Agenda for the

Independent Hearing And Assessment Panel Meeting

29 August 2016 – 6.00pm

1 212-218 CANTERBURY ROAD, CANTERBURY: DEMOLITION, CONSTRUCTION OF TWELVE STOREY MIXED USE DEVELOPMENT WITH BASEMENT PARKING

Figure 7 – the cross section shows the height of proposal (Stage 2) to the left, compared with the approved building (Stage 1) to the right. The outline of the original design is shown by the broken blue line. The Sydney Trains power line and easement are shown to the left.

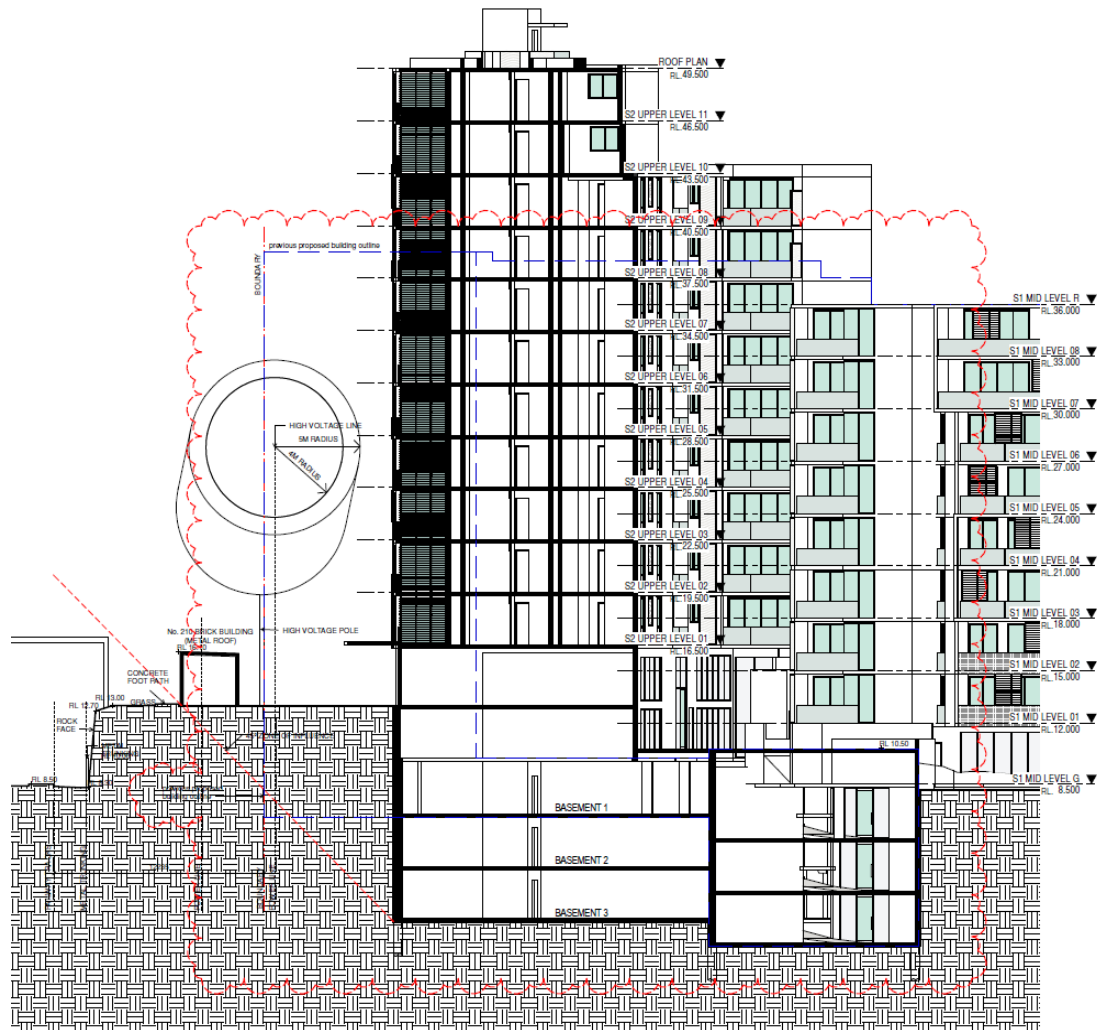
Figure 7 shows the redesigned building's relationship with the railway and compares the original proposal (broken blue line) with the revised design. Pedestrian entry to the building is via a series of ramps and stairways off the Canterbury Road footpath, leading to the central "piazza".

A 'through site link' was previously designed at ground level off the central piazza to the south-eastern boundary, which had potential to provide a path into the adjoining, former bowling club site. This is no longer proposed, being replaced by the pedestrian space between the building and the railway on the site's north-eastern side, shown to the left of the building in Figure 7.

Figure 8: Shadow study of proposal at 212-218 Canterbury Road Canterbury for 21 June, from 09.00 to 15.00.

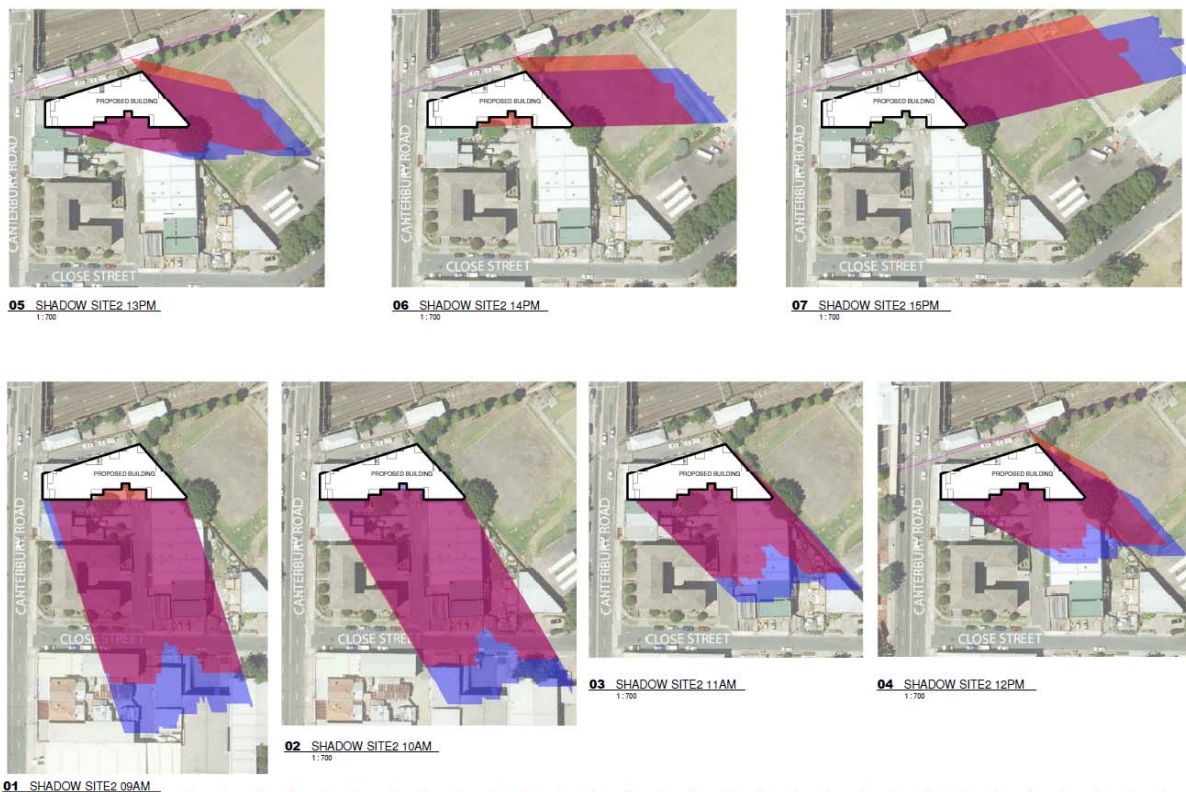
- Overshadowing of adjoining land will not create adverse impacts or restrict the development capacity of adjoining land. Referring to the diagrams below, the applicant submits that the revised development's shadows (pink and purple) are satisfactory when compared with the original, largely compliant building (pink & orange) and due to all surrounding land receiving sufficient sunlight at different times of the day.

- While additional height does add an element to the corner, this is inconsistent with the uniform building height of buildings along the railway envisaged and enabled by our Canterbury LEP and DCP.
- The photomontages above show the additional height and reduced footprint do not completely alleviate the building's bulkiness, especially when viewed from the north.
- There are additional overshadowing created by the subject development over adjoining lots.

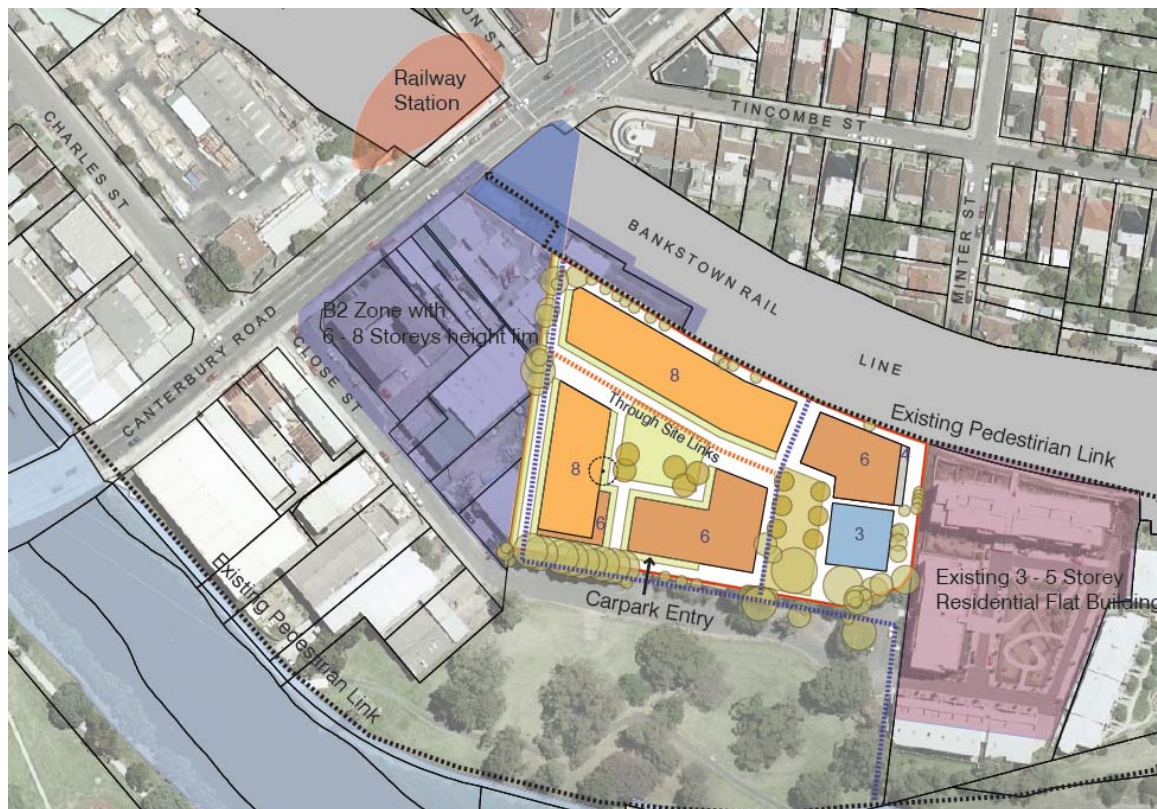
Figure 9 shows an extract of the master plan prepared in support of the planning proposal. It shows a series of pedestrian pathways between and alongside residential building envelopes of three to eight storeys, located around a central open space. Some of these paths enable access to Close Street and open space between this street and the river, connecting to the walking/cycle path along the riverbank.

Two of these paths terminate in the bowling club site’s north-western corner adjacent to the land the subject of this report. The master plan appears to have relied upon a path on adjacent railway land shown as a broken black line. In 2014 Sydney Trains formally advised Council that no access to this path (from the Bowling Club land) would be permitted.

Strategically, the pedestrian link proposed in the railway easement has potential to link with land to the site’s east, and integrate with the town square proposed by the Canterbury Town Centre part of the DCP (addressed later).
